LANDSCAPING LLC.

Howard County Health Department- Well & Septic Program

From: Cabahug, Joseph
Sent: Friday, April 06, 2018 4:14 PM
To: 'mark@rhinelandscaping.com'
Subject: 14370 Musgrove Farm - Well Line

14370 Musgrove Farm Ct - 3/28/18
-well line (white) runs through proposed pool (orange)

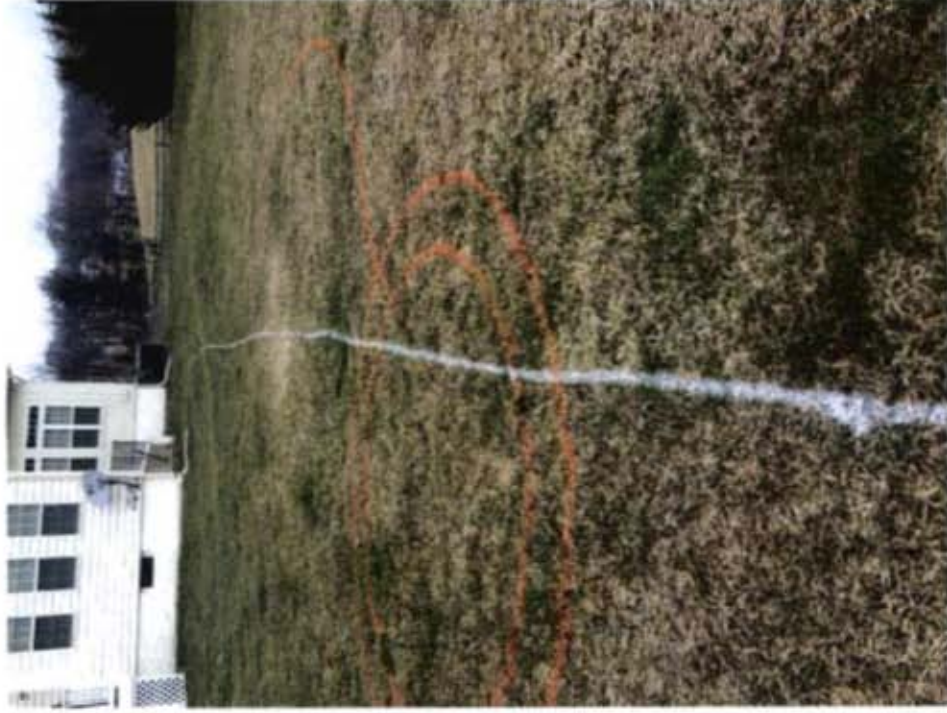
Please scan a statement on a company letter head certifying that the entirety of the well line at the above address will have adequate cover to meet the 36" frost line upon completion of the project. Upon receipt of this signed statement, which will be incorporated with the file record, the well line inspection will be approved.

Thank you for taking the time to speak with me regarding the well line at 14370 Musgrove Farm Ct. This letter is to confirm that we understand the frost line is 36" below the finished grade. We will be adding additional fill and the entire well line will be at least 36" below grade when the project is complete.
